Ashbourne SHD, Ashbourne, Co. Meath

Preliminary Design Stage Quality Audit

200059-DBFL-TR-XX-RP-C-0001

Problem G1 – Ramped access to home zones

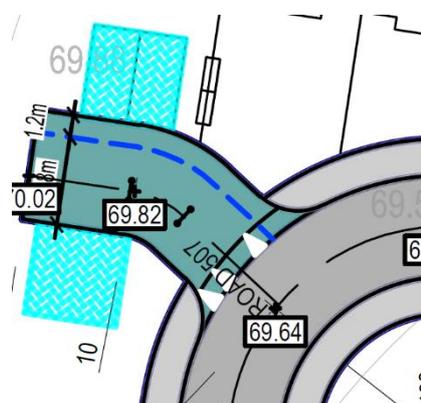
A number of locations within the development provide a ramp into the “Home Zone” residential areas. In some locations, the ramp appears to be situated in the direct line of travel for the footpath and crossing for pedestrians, as shown in the example image. Therefore, there is a level difference and crossfall at where pedestrians will want to cross the road. This may lead to trips and falls by pedestrians, in particular, visually impaired pedestrians.

It is recommended that the footpath be diverted slightly away from the ramp and tactile paving provided so as to indicate to pedestrians, in particular, vulnerable road users, where to cross.

Problem G6 – Main Spine Road Landscaping Proposals

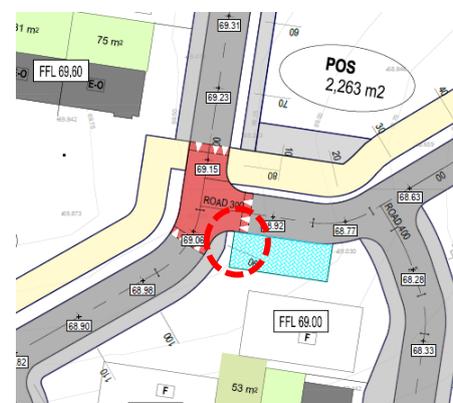
It is noted that tree planting within the verge provides a benefit in terms of traffic calming, however, this needs to be safeguarded in terms of visibility splays at internal junctions and head height for cyclists along parallel cycle tracks.

Ensure that trees planted within the development maintain visibility for drivers. Also ensure that trees branches do not impede into the cycle tracks and block accessibility for cyclists.

Problem S1 –Raised Table blocking parking space

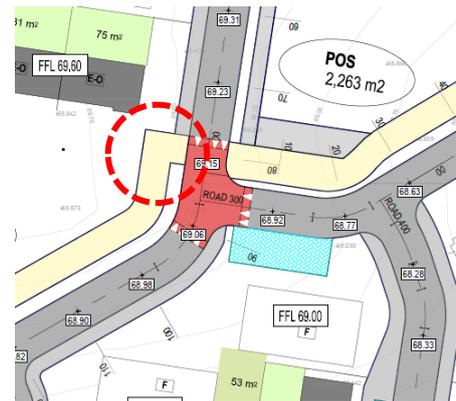
The ramp of the raised table is currently blocking the perpendicular parking space adjacent to it, leading to level differences when accessing the space. This could result in unsafe vehicle manoeuvres when accessing/egressing the parking space and could lead to vehicles colliding with other parked vehicles.

It is recommended that the parking spaces are moved so that they are not blocked by the ramp within the raised table.

Problem S3 – Shared path buffer

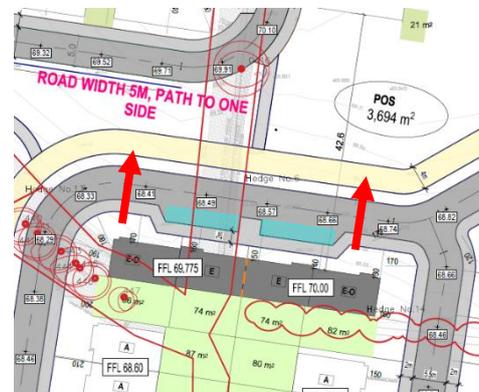
The shared path appears to have a buffer between the path and the road carriageway along its length. It is unclear as to what this buffer entails and whether pedestrians/cyclists will have accessibility through this buffer area. Should the buffer be hard landscaping, this will hinder accessibility to and from the path and key travel desire lines.

It is recommended that the buffer be accessible for pedestrians and cyclists to access the shared path. Should landscaping be provided within the buffer, ensure that there are accessibility points on all key desire line locations for pedestrians and cyclists.

Problem S4 – Accessibility for the Shared Path from the R135

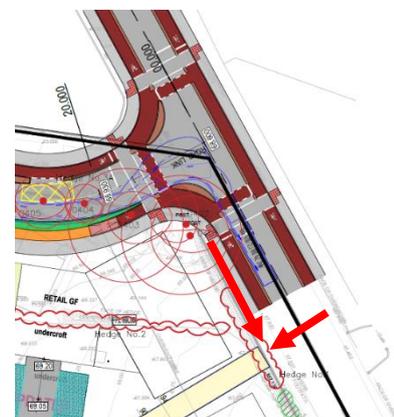
It is unclear as to how southbound cyclists travelling along the R135 (and cyclists travelling northbound from the direction of the intended shared path) will access the shared path into the development. There appears to be no formal facility to allow cyclists to travel safely between the signal-controlled junction and this path. This could lead to cyclists undertaking unsafe manoeuvres, possibly on the footpath

which may conflict with pedestrians in this location or crossing the busy R135 with no crossing allocated.

It is recommended to provide a safe connection link for cyclists travelling southbound from the proposed cycle protected junction to the shared path.

Problem S5 – Access for pedestrians and cyclists on main spine road

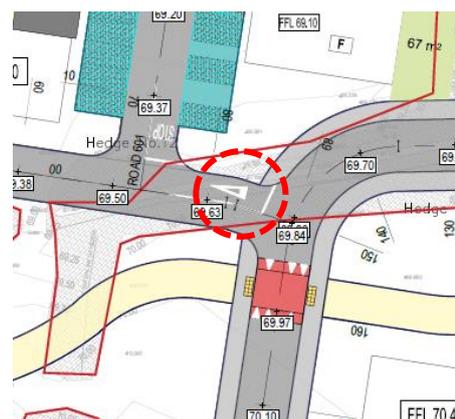
In a number of locations, there appears to be no access for cyclists travelling from side road junctions to the main cycle track facility along the main primary road within the development. Grass verges are located between the cycle track and the road carriageway. Similar connection issues are present for pedestrians.

Gaps within the grass verge should be provided at strategic locations for pedestrians and cyclists to access the footpaths and cycle track facilities located on the opposite side of the main spine road.

Problem S7 – Shuttle system conflict with vehicular accesses

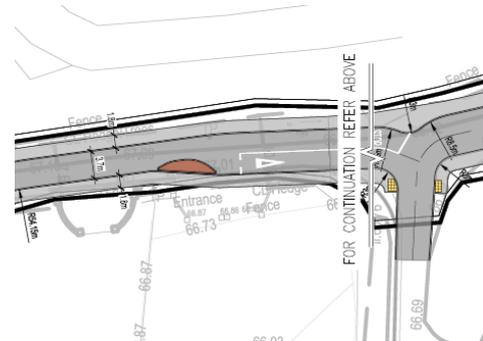
The proposed island and road markings allocated for the shuttle system along Hickey's Lane appear to be blocking access for the residential driveways located here. This could result in accessibility issues for residents located here.

The shuttle system should be revised so as not to block residential property accesses.

Problem S8 – Shuttle system visibility

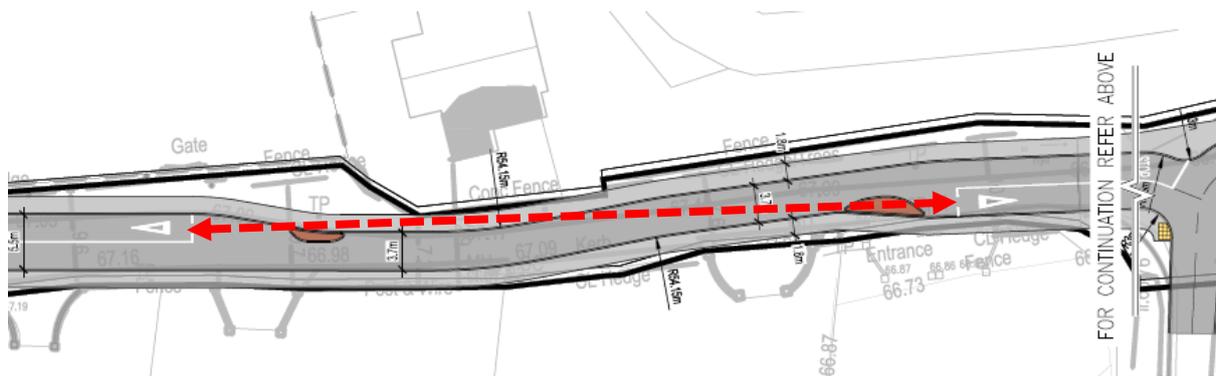
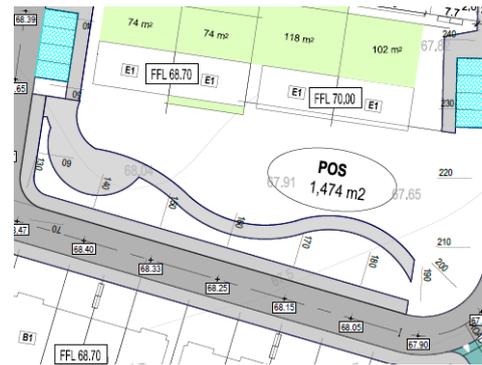
The length of the proposed shuttle system appears long at 85m approximately. It is unclear as to the level of visibility between each end of the shuttle system. Reduced visibility could lead to head on collisions between vehicles.

Ensure that adequate sightlines are provided along this section. If sightlines are not achievable, alternative solutions could be explored.

Problem S10 – Clarity on crossing type

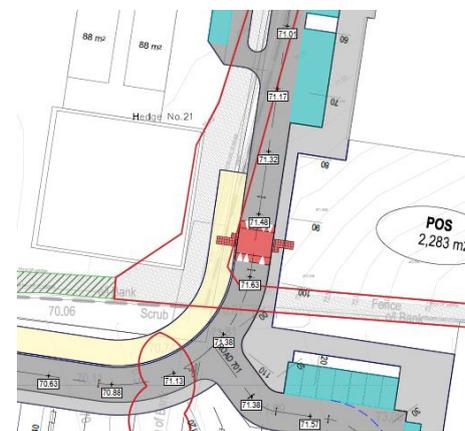
The raised crossing located south of the reserved school site appears to be allocated as a signal-controlled crossing, however, there are no road markings to indicate to vehicles to stop at this crossing. This may lead to vehicles failing to stop while pedestrians are crossing which may result in a collision.

Road markings should be provided to indicate to drivers that they are approaching a mid-block signal-controlled crossing.

Problem S11 – Narrow footpath at parking bays

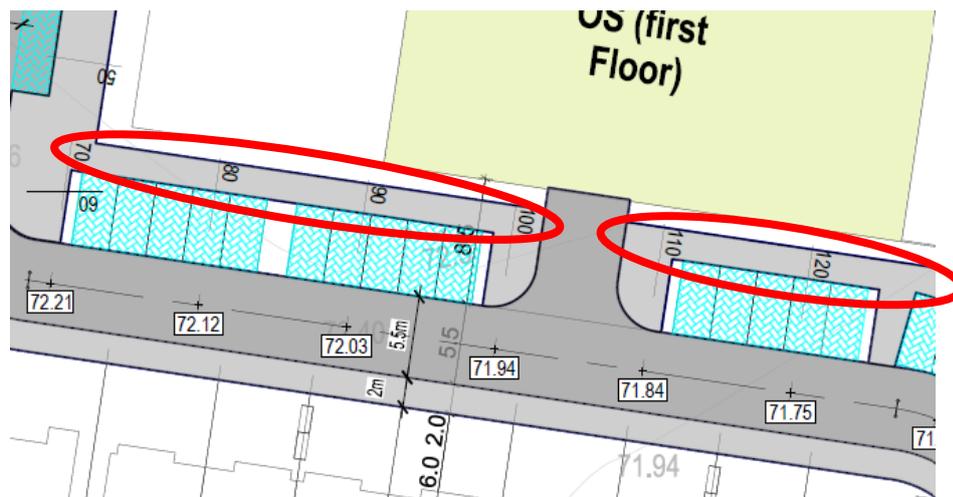
Some locations within the development appear to have narrow footpaths in locations of perpendicular parking bays. There is the possibility that vehicles could overhang the parking space into the footpath area, reducing the effective width further in these locations. This could lead to accessibility issues, in particular for wheelchair and pushchair users.

Ensure that footpaths have adequate width to comfortably accommodate vulnerable road users.
Ensure that vehicles do not overhang the footpath in these locations.

Problem S13 - Abrupt end of main link road

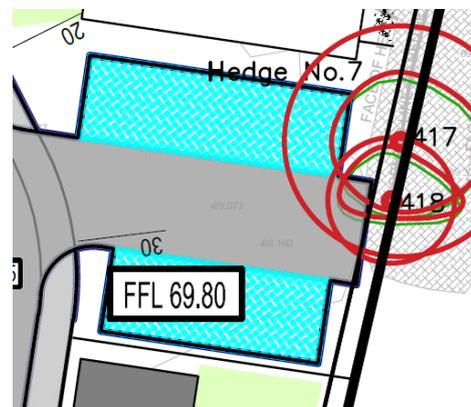
The main link road of the development ends abruptly. It is assumed that this link road will continue into future development lands adjacent to this site. There is a risk that, should the adjacent lands

be developed after construction of this development, the main link road will cause confusion for drivers, cyclists and pedestrians as it will end abruptly.

It is recommended that temporary measures be put in place such as appropriate advanced warning signage and a turnaround facility in order to accommodate drivers who travel along this main link road and wish to turn back around.
